**RAJIV GANDHI UNIVERSITY OF KNOWLEDGE
TECHNOLOGIES-AP**

Corrigendum-I

Ref. No: RGUKT/SKLM/E-Proc/Student Amenities/Tender 6/Steel cots/T12/ 2019-20,
dated. 03 .08.2019

The following modifications have been done in our E-Procurement Tender Notice issued vide reference cited above for providing Student Amenities (Steel Cots) at IIIT Srikakulam, RGUKT-AP.

Specifications of Steel Cots

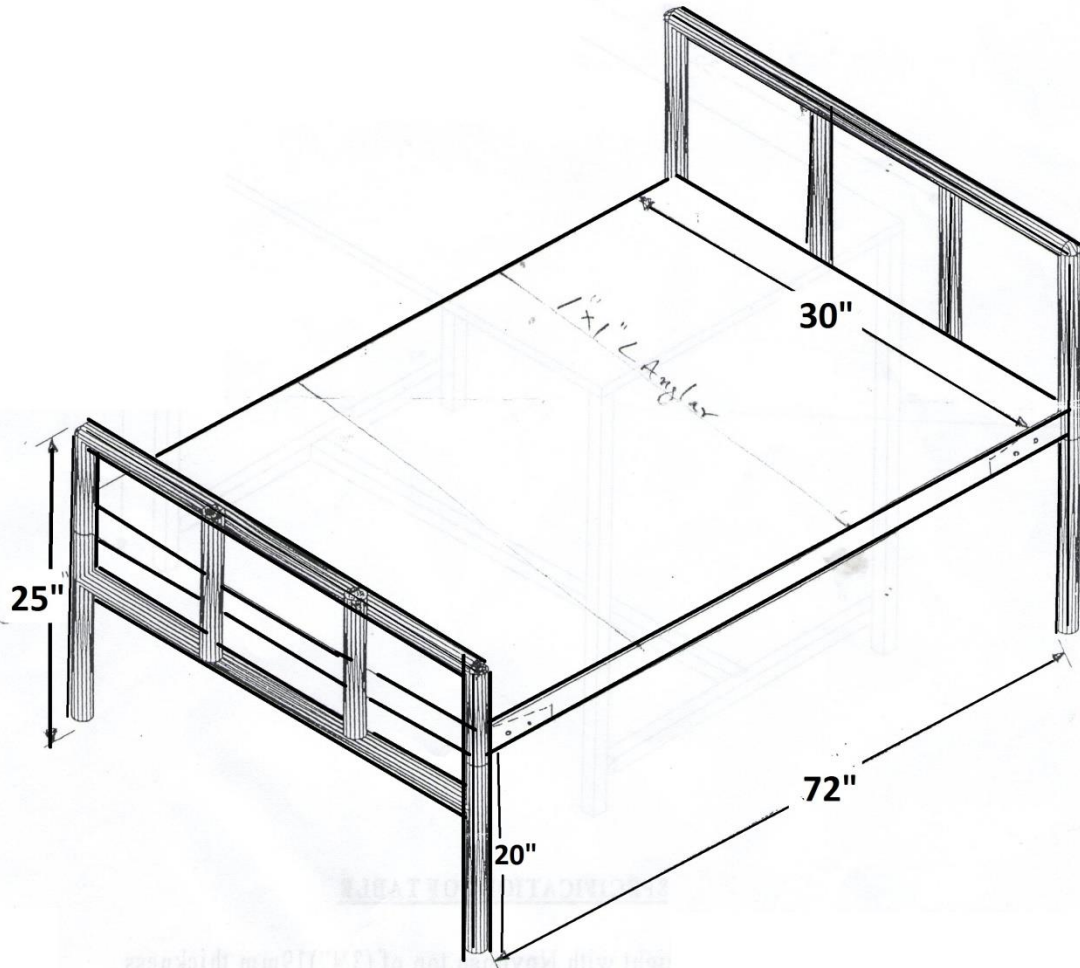
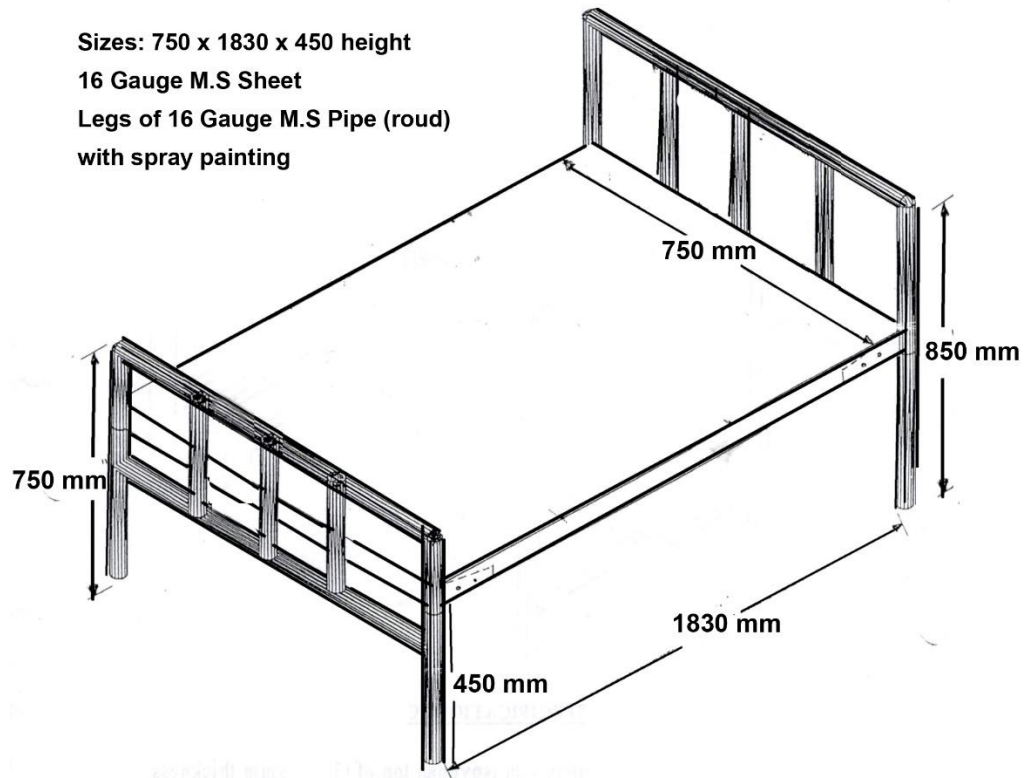
S.NO	Page no of original document	Clause no of original document	Item discription (As per Tender Document)	Amendments by IIIT-Srikakulam, RGUKT-AP
1	Page No-19	Requirements - Specifications of Steel Cots	Please refer to Annexure A of this corrigendum	Please refer to Annexure B of this corrigendum

Dimensions:
Horizontal base	Over all dimension of cot of size top frame (sheet) shall be length 1830 mm X Width 750 mm X height 450 mm. CR sheet thickness 1.6 mm
	Bed bottom 4 Sides bending 50mmX 30mm X 15 mm with 2 Reinforcement length of channels of size 15X50X50X50X15 CR sheet , 1 mm thickness flanged are welded inside the length wise with 5 inches gap
Frame	Legs CR Pipe Bows outside dia - 31.75 mm 1.6mm thickness Cross CR tube 25.40mmx1.22 mm thickness 3 no's filling CR tube 19.05xmm 1.22 mm thickness head bow height 850mmx Leg bow height 750mm
Fasteners	The MS flat for top horizontal base shall be fastened inside all of on all four sides with L-type brackets of size 50x 3mm thikness
Finishing	All material CR sheet & tubes as per IS- 513 1994 reaffirmed in 1998 . Spray painting of minimum thickness 50 microns

Sizes: 750 x 1830 x 450 height
16 Gauge M.S Sheet
Legs of 16 Gauge M.S Pipe (roud)
with spray painting
